GDA close-out for the AP1000 reactor

**GI-AP1000-SI-03 – Reactor Coolant Pump – Pump Bowl Integrity and Flywheel
Disintegration Case**

Assessment Report: ONR-NR-AR-16-005
Revision 0
March 2017

Figure 2: Hagg and Sankey principle

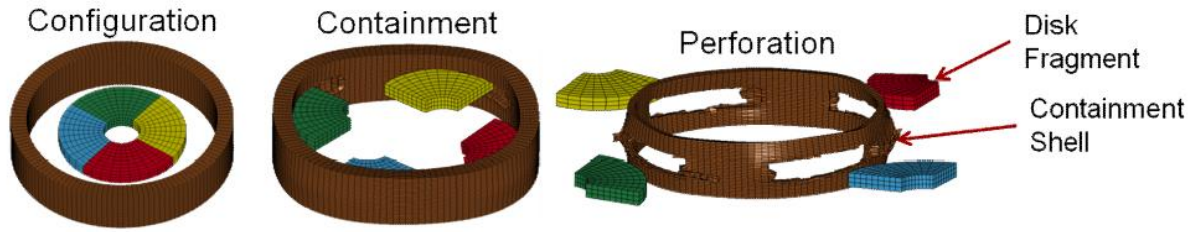
52. The queries in Reference 15 were mainly concentrated on the postulated flywheel disintegration analysis and assessment that used the traditional analytical / semi-

empirical Hagg and Sankey procedure based on a small range of burst discs and containment shell geometries. The Hagg and Sankey methodology prescribes a two-stage process as described below (see also Figure 2):

- Stage 1 – localised perforation failure of the containment shell on initial impact by the burst disc fragments. It is assumed that the perforation failure occurs when the energy transfer during impact, as measured by the energy loss of the burst fragment, exceeds the maximum compression and shear strain energy that the contact zone of the containment shell is capable of absorbing.

- Stage 2 – if the localised perforation does not occur, it is assumed that the residual energy is dissipated in the form of tensile strain throughout an extended volume of the containment shell material. Failure occurs when the residual energy exceeds the allowable strain energy of the extended volume.

53. I assessed (Ref. 16) the postulated disintegration report from the pump manufacturer KSB (Ref. 17) and, after consideration of the claims, arguments and evidence provided in Westinghouse's response to RQ-**AP1000**-1354 (Ref. 15), concluded that Westinghouse has adequately demonstrated the following:

- The underlying assumptions for judging the size of a simplified fragment are credible, conservative and bounding for the failure mechanisms related to the flywheel design.

- The differences in geometry and material properties of the RCP flywheel and containment do not change the underlying basis and assumptions made by the Hagg and Sankey methodology.

- The method of calculating the area of impact by the simplified fragment mass is conservative. The assumption that the impacting mass is equal to the fragment mass is realistic and conservative despite the narrow annulus between the flywheel and heat barrier.

- Neglecting the effects of water surrounding the flywheel is conservative.
54. The Hagg and Sankey methodology is a well-established, traditional method for assessing spun discs and casings. It is recognised in the turbomachinery industry as a reliable and simple method for assessing disc failure and casing integrity. It is also stated in the R3 Impact Assessment Procedure (Ref. 12) as a reliable methodology for assessing containment of missiles. The R3 procedure is a well-recognised RGP within the UK nuclear industry for undertaking impact assessments following simplified methodologies.
